ADDENDUM 003
Request for Bid
St. Louis Economic Development Partnership
for Constructing or Improving
Olive / Lindbergh Interchange
STP-4922(604)

GENERAL PLAN AND ELEVATION
ROUTE 340
SHEET 1 OF 11

BRIDGE: ROUTE 340 OVER LINDBERGH BOULEVARD (RTE. 67)

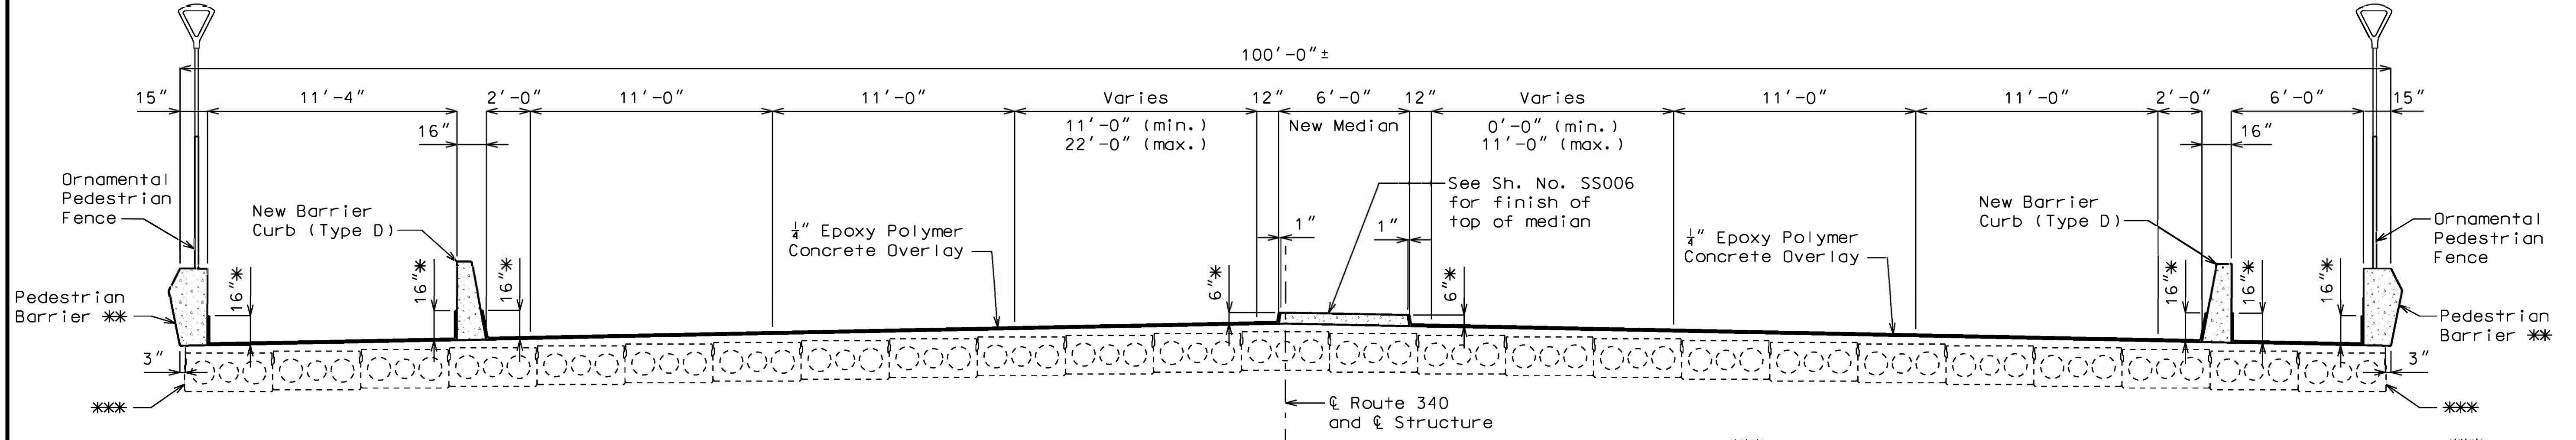
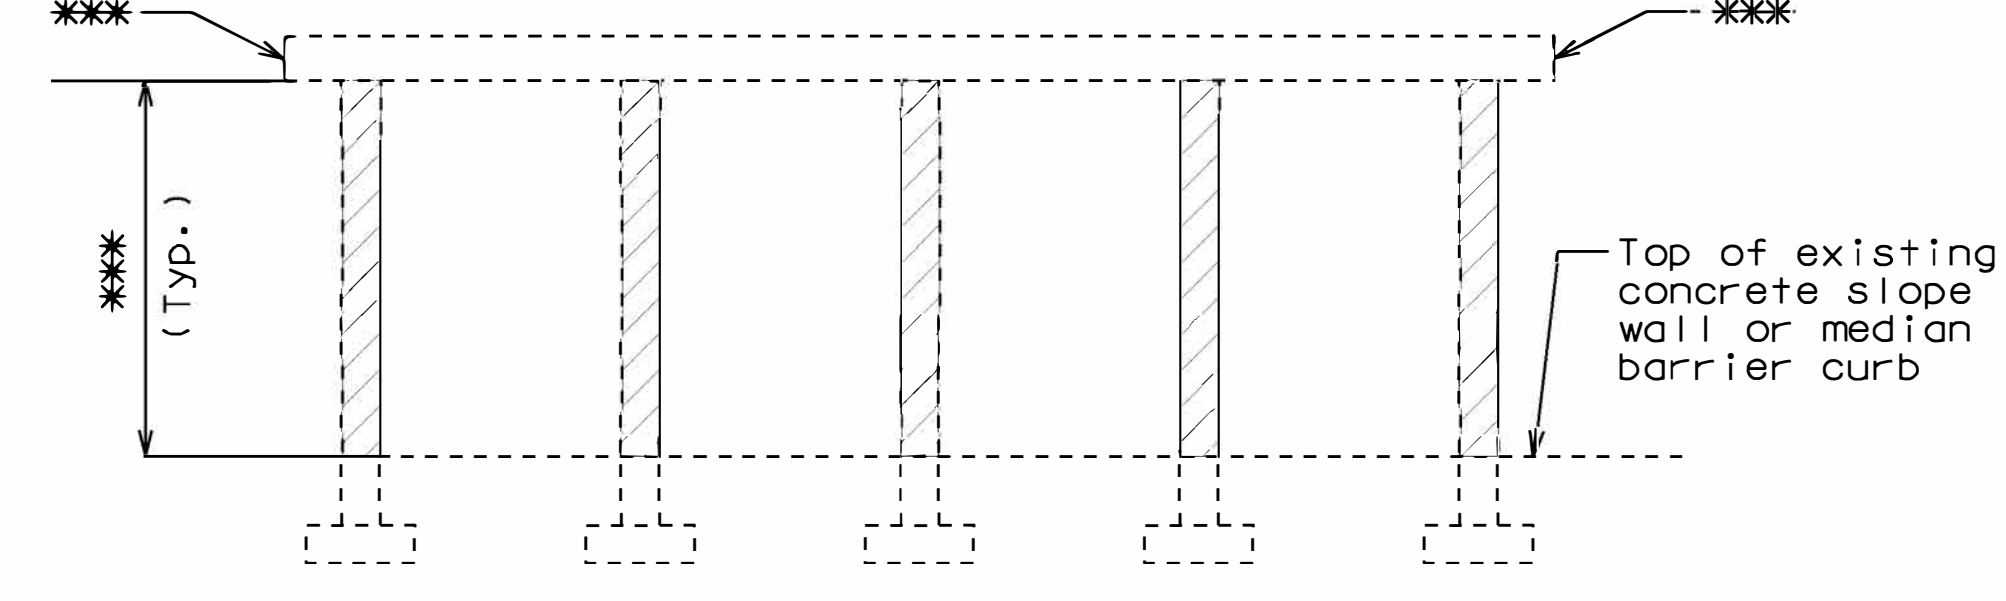
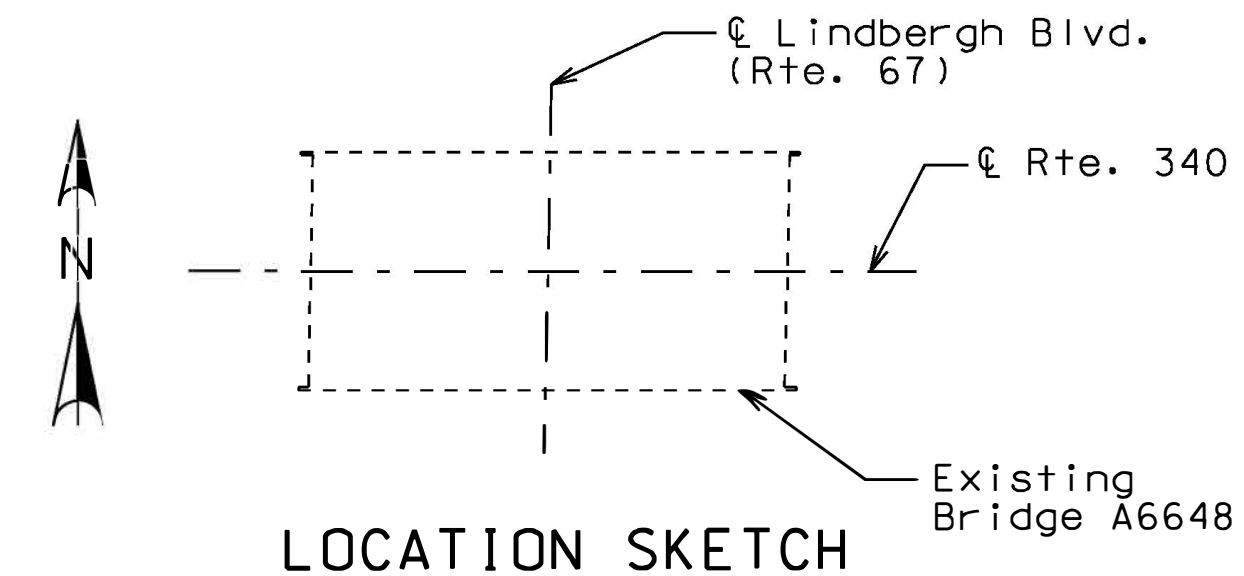
- 1) Notice to Contractors, Table of Contents, added Section 20 Tax Exempt Status.
- 2) Notice to Contractors, page 5 of 5, added Section 20 Tax Exempt Status.
- 3) Bridge Sheet 1 of 11 will replace Alt 04 Protective Coating.
- 4) Itemized Bid Form Page 7 of 7 will replace Alt 04 Protective Coating.
- 5) Itemized Bid Form Page 2 of 7 will replace Compacting Embankment.
- 6) Itemized Bid Form Page 6 of 7 will add Settlement Gauge.
- 7) Add JSP FFF. Settlement Monitoring.
- 8) Itemized Bid Form Page 6 of 7 will set the unit bid price for Misc. Ameren Connections.
- 9) Contractor's questions from after Pre-Bid Meeting.
- 10) Special Sheet SS005, structure reinforcing is not required if cast in place.
- 11) Revised JSP G for aggregate material required
- 12) Quantity Sheet 1 of 4, Compacting Embankment quantity revised

C3 REVISED 06-19-2020

** Coat all exposed faces of Pedestrian Barrier not coated with Epoxy Polymer Overlay with Protective Coating - Concrete Bents and Piers (Epoxy) (Tinted). See Special Provisions.

C3 Protective Coating - Pedestrian Barrier, Concrete Bents and Piers (Epoxy) (Tinted)

Note: See Job Special Provisions for details of Protective Coating - Concrete Bents and Piers (Epoxy) (Tinted).
